Residential Development at Huntly Lodge Farm, Marquis Drive, Huntly

Technical Note

PROJECT REFERENCE: 141504 TN02

Figure 4-1: Huntly Core Paths Plan

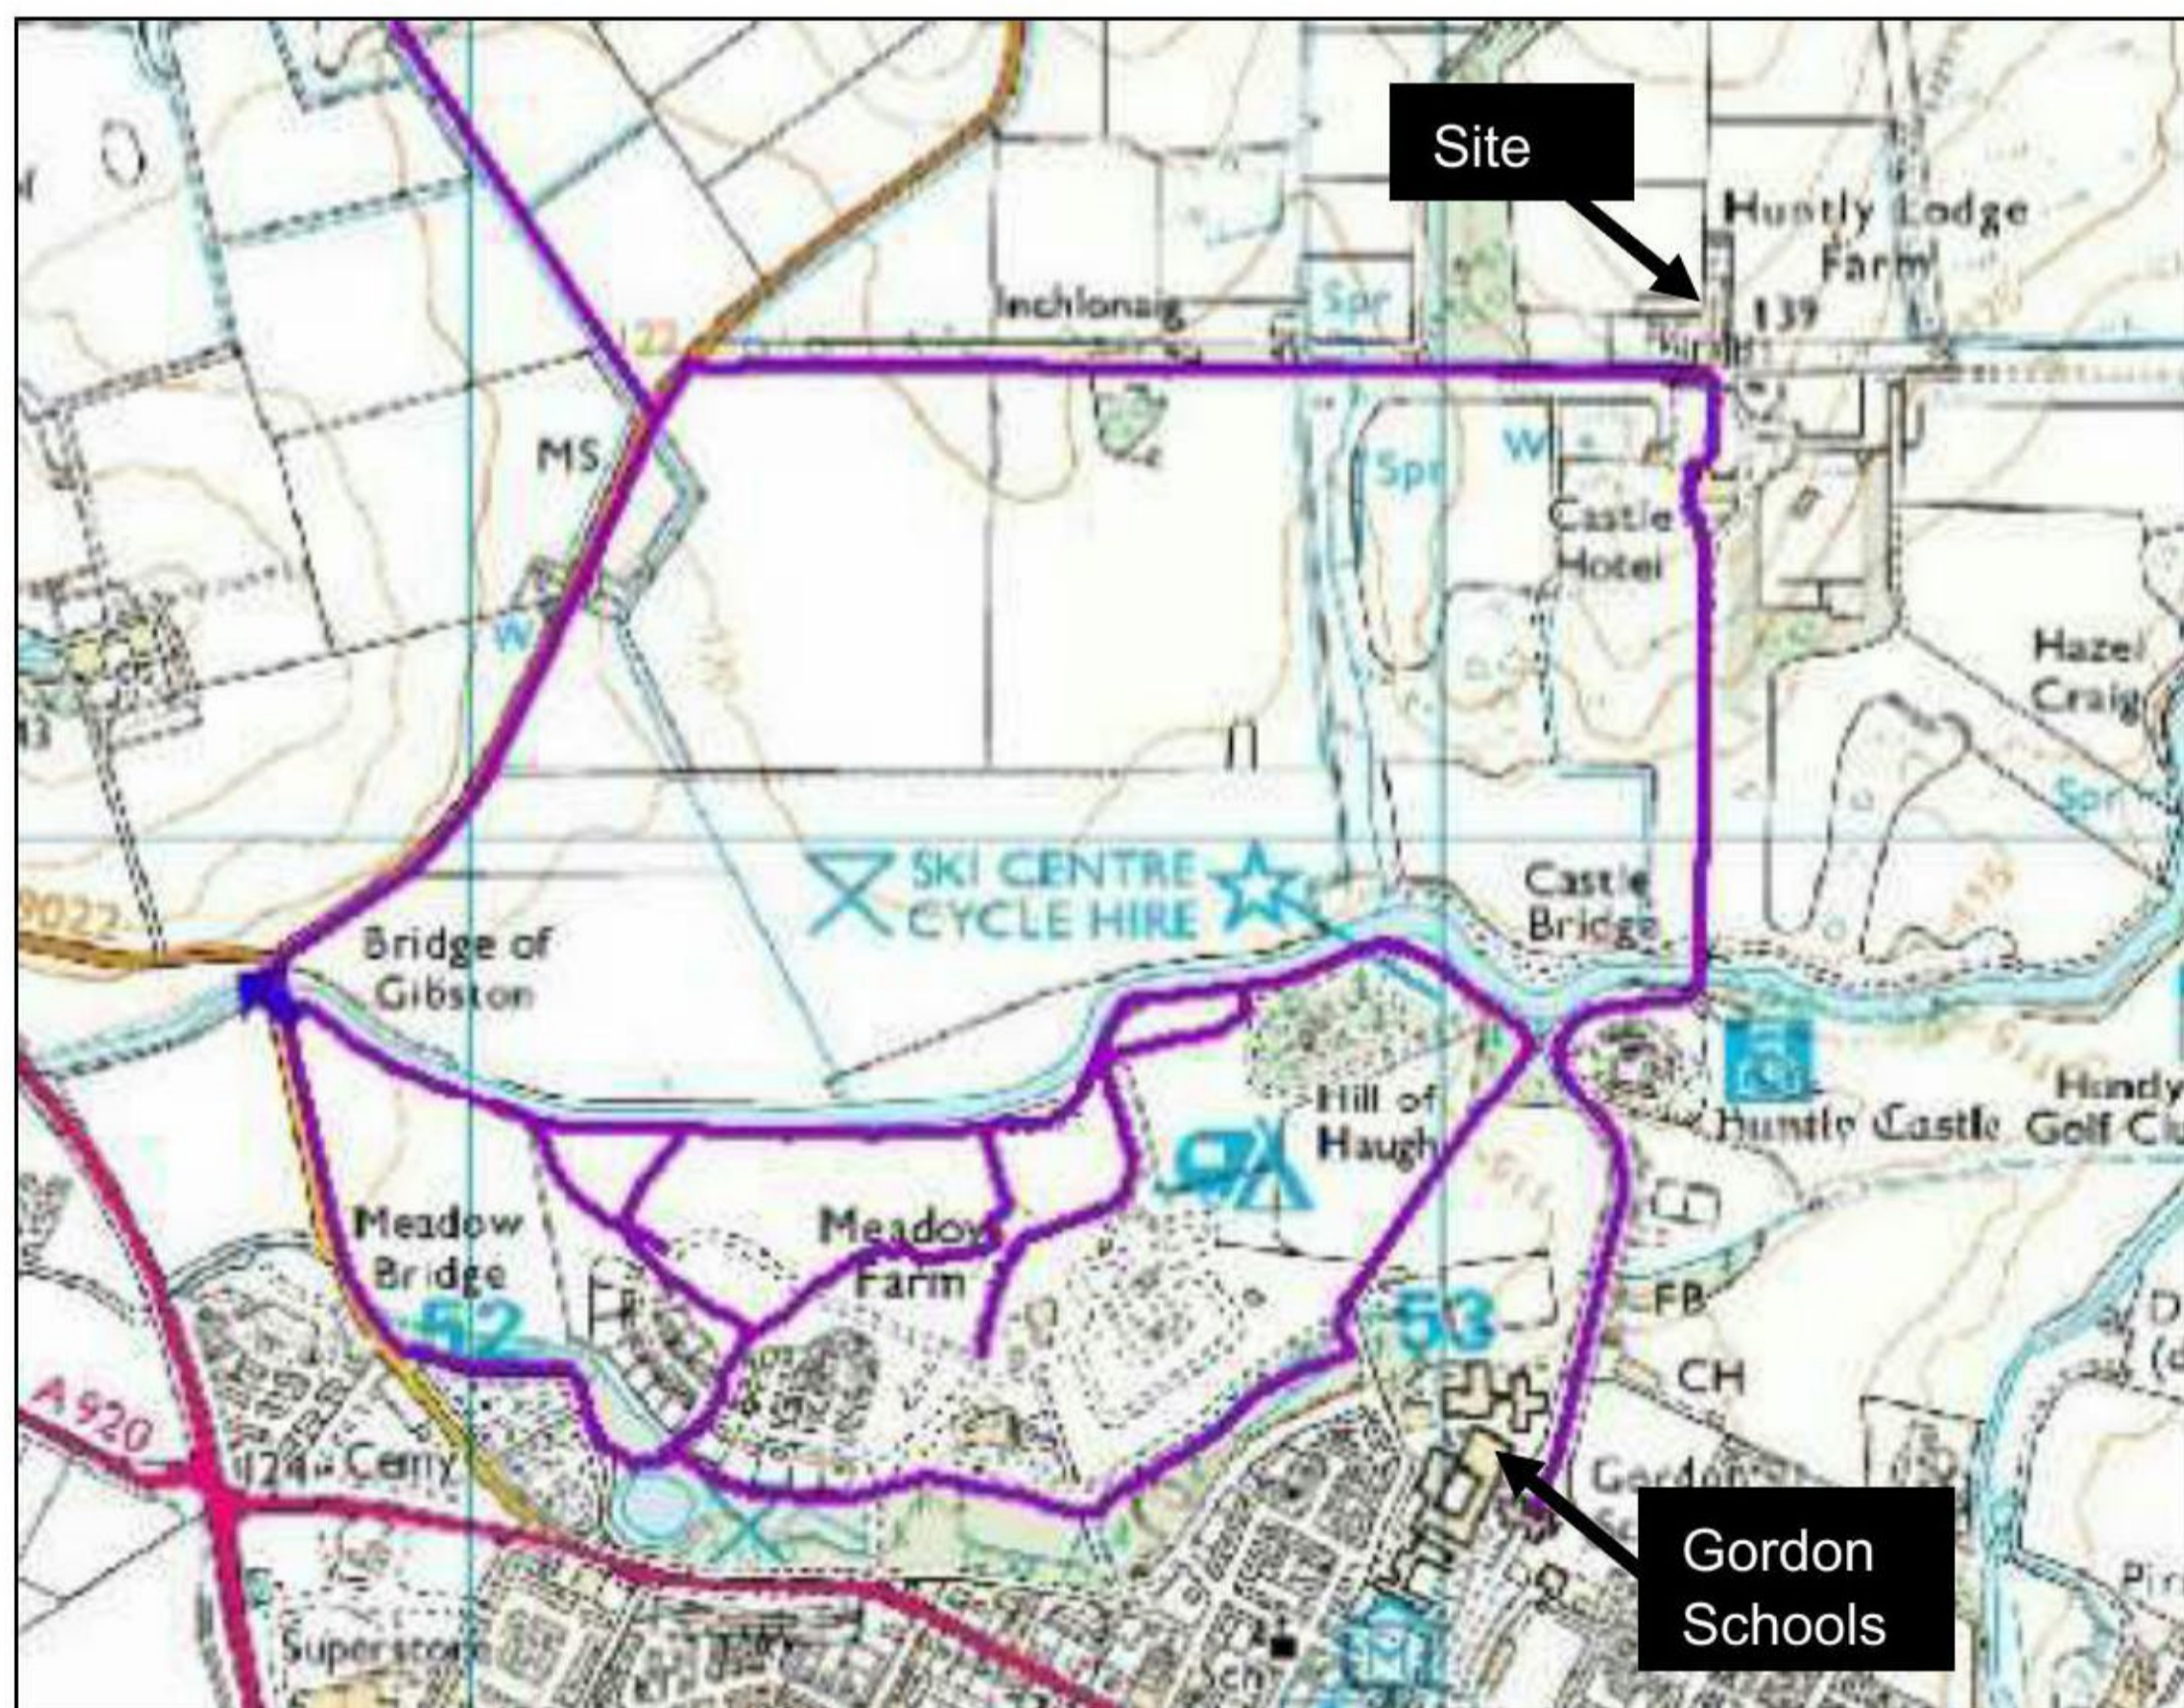
- 4.1.1 The proposed development sites are located outwith Huntly within the rural area. A walking / cycle route exists from Marquis Drive via the Huntly Castle Hotel and the bridge over the River Deveron and continues via the existing footpath network providing access to / from Huntly Castle and onwards to provide access to the Gordon Schools (Primary and Academy).
- 4.1.2 The route is part of the Core Path Network and is approximately 1.2km and therefore within the 2-mile and 3-mile walking limit for Primary and Secondary schools respectively. Figure 4-1 below is an extract from the Huntly Core Paths Plan and identifies the route between the site and the Gordon Schools.

- 4.1.3 The bridge over the River Deveron is currently closed to traffic but continues to operate as a footbridge and is regularly used by pedestrians and cyclists. The route is recognised as a key part of the Huntly Core Path network and is a popular scenic walk used regularly by members of the public and tourists visiting Huntly Castle.
- 4.1.4 Children who currently reside at Marquis Drive use this route, however the route is unlit between the site and Huntly Castle and therefore does not fully meet the Council's safe routes to school criteria. Beyond Huntly Castle the route is lit to where access to the schools is taken. However the route is not considered to be unsafe for a child accompanied by a responsible adult.

- 4.1.7 It is therefore envisaged that any children generated from the proposed development would also be eligible to travel to / from school via school transport, with the option to walk / cycle via the existing Core Path route via Huntly Castle. As Marquis Drive is a private road, pick up / drop off would be at the junction with the B9022 public road and pupils would be expected to make their own way to / from there, or be transported by their parents. Marquis Drive is also identified as part of the Core Path network, forming a popular circular route from Huntly via the B9002.
